SERVICE BULLETIN

Title: 19XL Continuous Improvements

Number: C9403

This bulletin contains information on revisions that have been made to the 19XL centrifugal chiller product.

Figure 1
Old Style

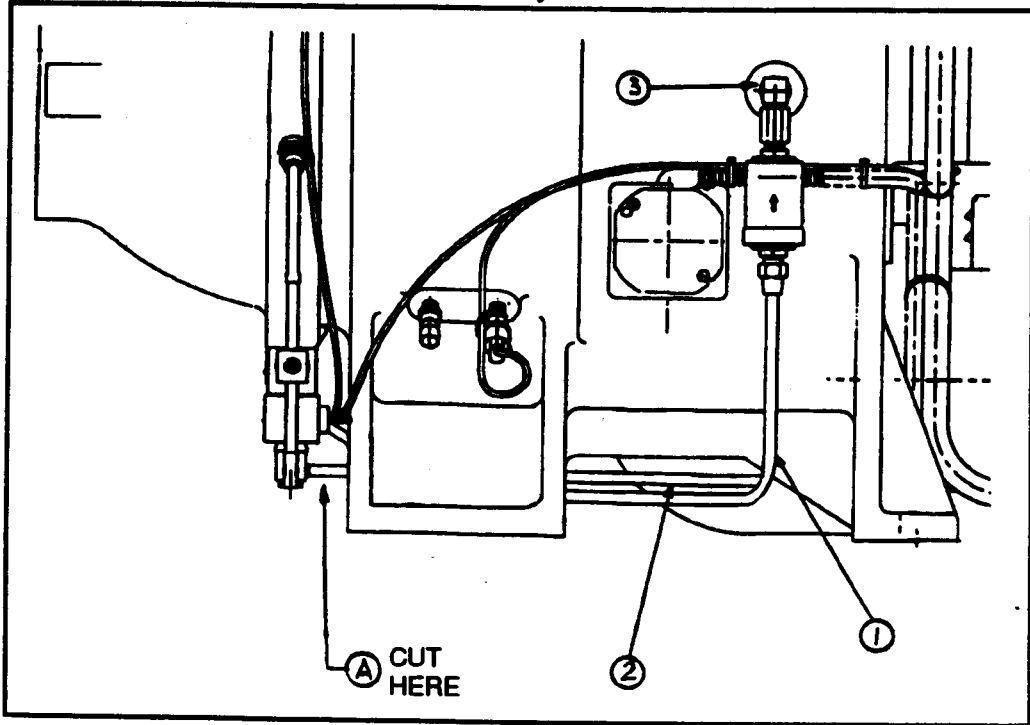
Machines shipped after October '92 have a revised oil reclaim system that is less costly and more reliable. The changes include a new evaporator suction filter, a new style eductor, and piping changes to fit the eductor into the system. The strainer between the eductor and the low pressure side of the compressor has been eliminated. A drawing has been attached to illustrate the new eductor piping. A retrofit kit (19XL660006) is available if a new eductor is to be ordered in place of the old eductor.

Remove Old Fittings: (Refer To **Figure 1**)

1. Pump out refrigerant from cooler. Isolate refrigerant in the condenser, or in a separate storage vessel. Use the pumpdown lockout feature on the PIC controls test.
2. Cut the oil suction line, line 2, at point A. Leave enough tubing to braze a fitting onto this line.
3. Remove the high pressure line, line 1, by loosening the flare nuts.
4. Remove line 2, remove strainer on other high side line. It is recommended that the low side filter be changed at this time. It is located to the left of the float box. Remove connection into the compressor casting at location 3.

Install New Fittings: (Refer to **Figure 2**)

5. Install line 1. Install line 10 by brazing the tubing into the original tubing. Cut the new tubing to size. Use the coupling fitting, item 11, to braze the copper lines together.
6. Install the remaining components, items 2-9.
7. Tighten all fittings, then leak test all connections. Recharge the machine, use the PIC controls "terminate lockout" function to equalize or recharge the unit. Installation is now complete.
